ANALOG DEVICES

Comments on 802.3dg Draft 0.2

Philip Curran
Brian Murray
Jacobo Riesco

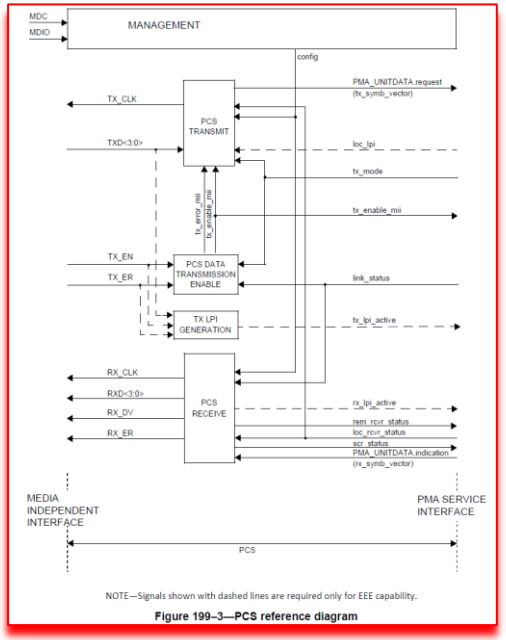
- Should not need to explain the meaning of ^ for each use case in an equation

- Notation in equations are generally not defined

- Figure 199-3 (PCS reference diagram) has to be redrawn
  - Acknowledged in the Editor's note

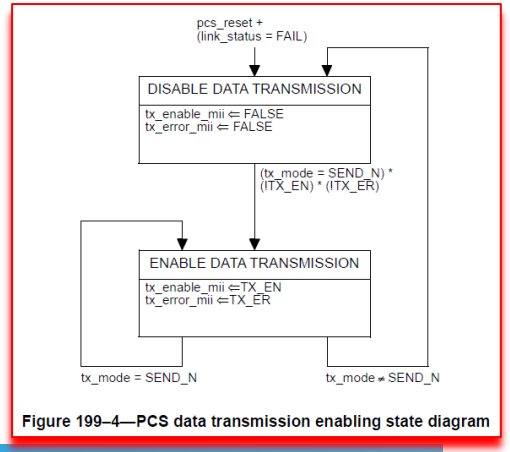
> ***Editor's Note (to be removed prior to Working Group Ballot):***
>
> Figure 199-3 is a copy of Figure 146-4 and may need modification.

Figure 199–1—Relationship of 100BASE-T1L PHY to the ISO/IEC OSI reference model and the IEEE 802.3 Ethernet model

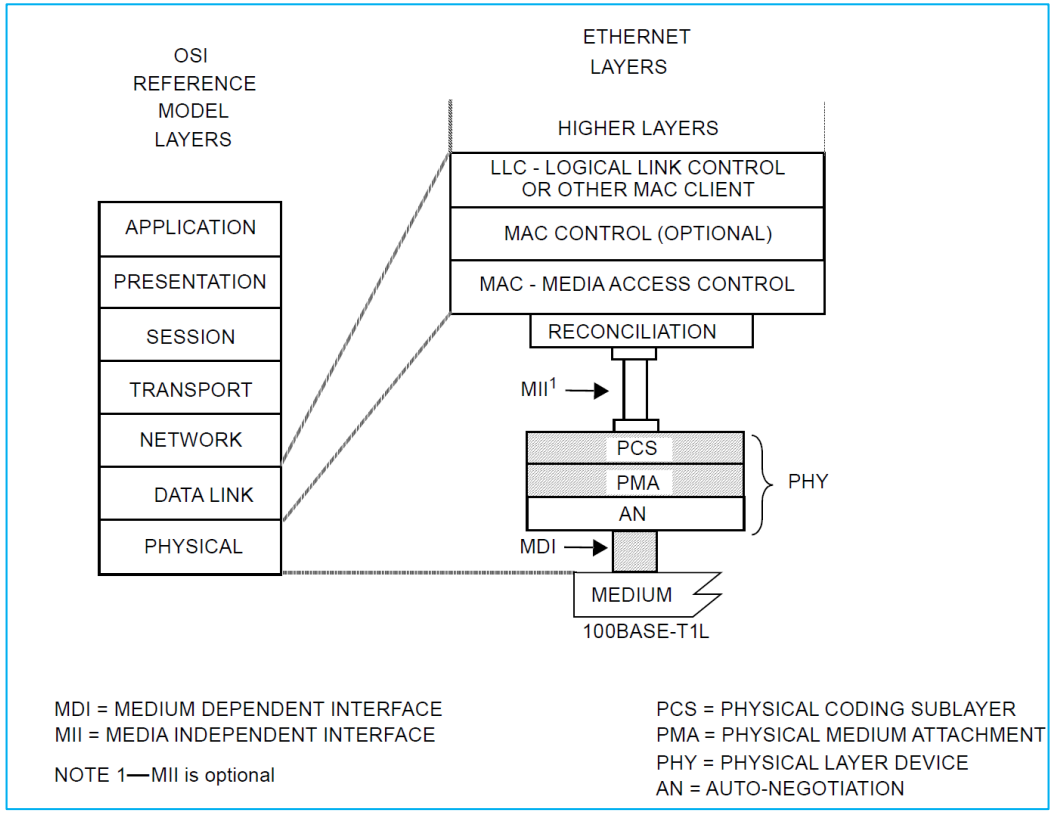
- Figure 199-1 (Relationship to the ISO/IEC OSI reference model) need to be updated, as Auto-Negotiation is not optional
  - Remove “NOTE 2—Auto-Negotiation is optional”
  - Acknowledged in the Editor’s note

> ***Editor’s Note (to be removed prior to Working Group Ballot):***
>
> Edits to Figure 199–1 may be needed.
